RE: Ridgecrest Solar Power Project (RSPP), Docket No. 09-AFC-9, Responses to CEC Data Requests for Cultural Resources (DR 105 and 262) and Soils and Water Resources (DR 170 to 172)

RIDGECREST SOLAR POWER PROJECT (09-AFC-9)
CEC STAFF DATA REQUEST NUMBERS 105 and 262

RIDGECREST SOLAR POWER PROJECT (09-AFC-9) CEC STAFF DATA REQUEST NUMBERS 170-172
Technical Area: Soils and Water (AFC Sections 5.12 and 5.17) Response Date: February 19, 2010

DR-CULT-105-2
Plan View of Impact Blocks
Disturbance Level
Above Ground

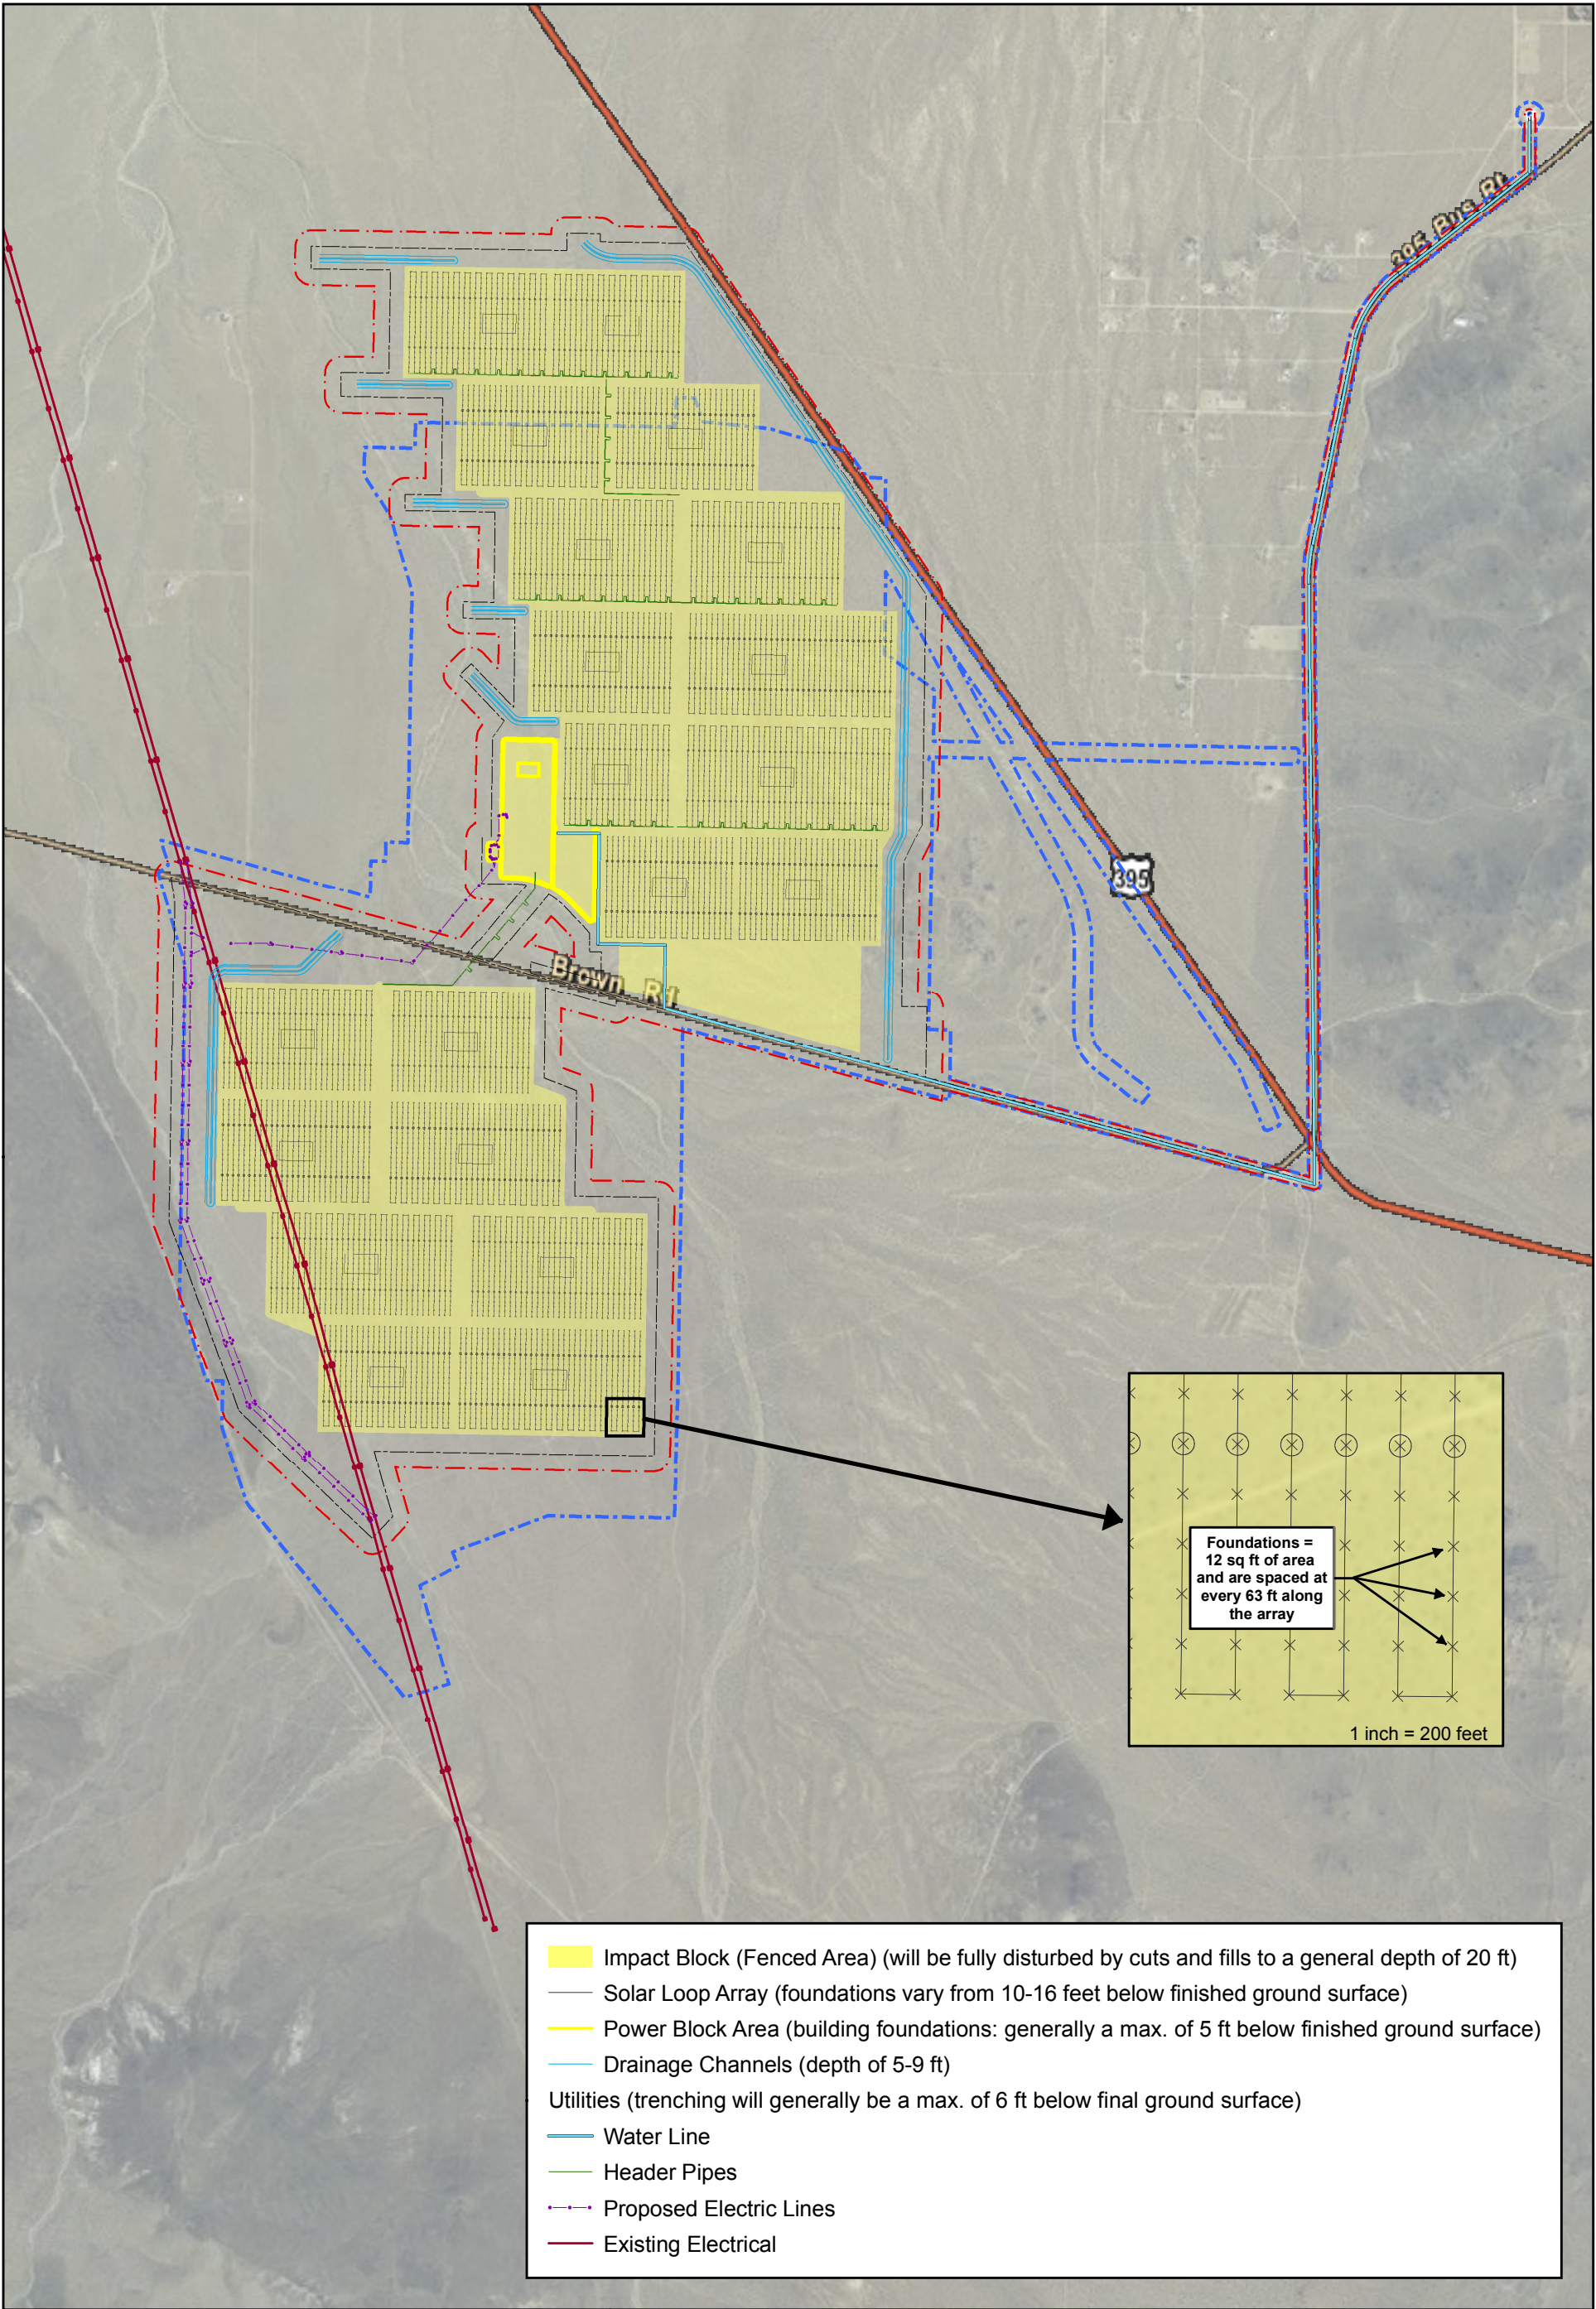
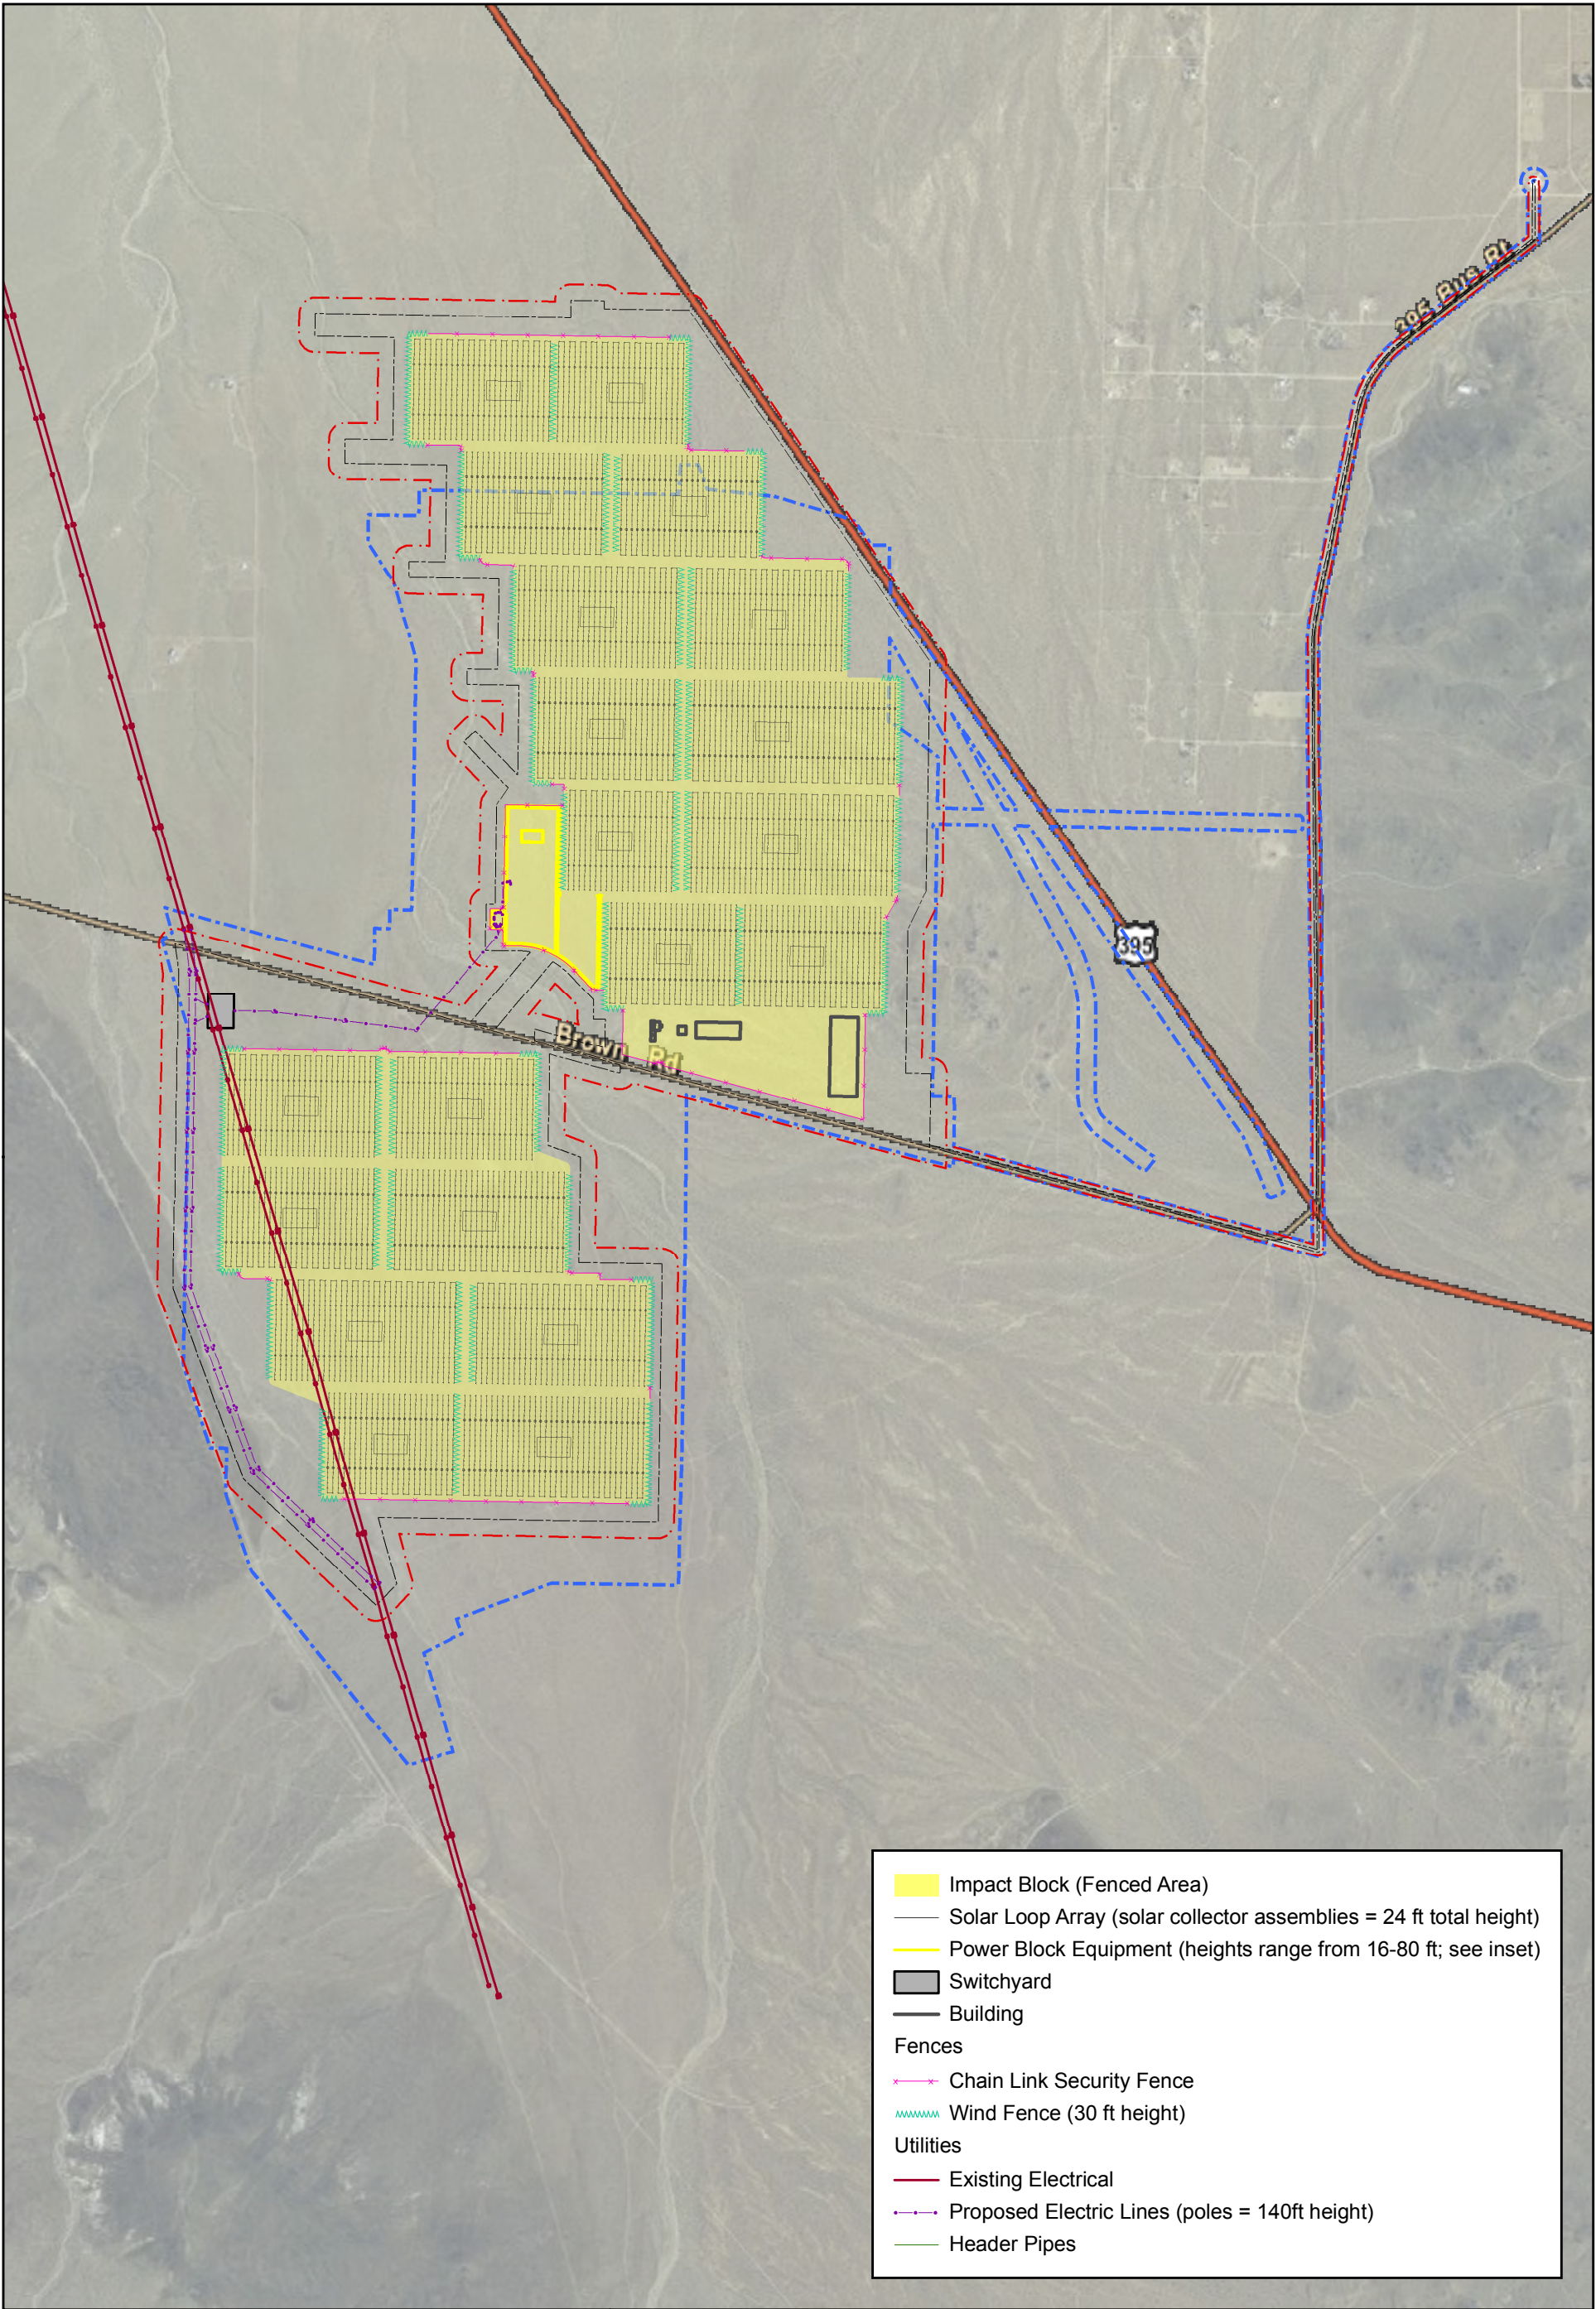
Please provide to staff a series of scaled and dimensioned plan-and-profile views of the proposed project's (and alternative locations') impact blocks.

Scaled and dimensioned plan and profile view of the proposed project's impact blocks are provided at the end of this section. For the Ridgecrest power block arrangement and heights, please refer to Figure 2-5 General Arrangement Power Block located in the Project Overview section of Volume 3 Data Adequacy Supplement, submitted to the CEC on October 26, 2009.
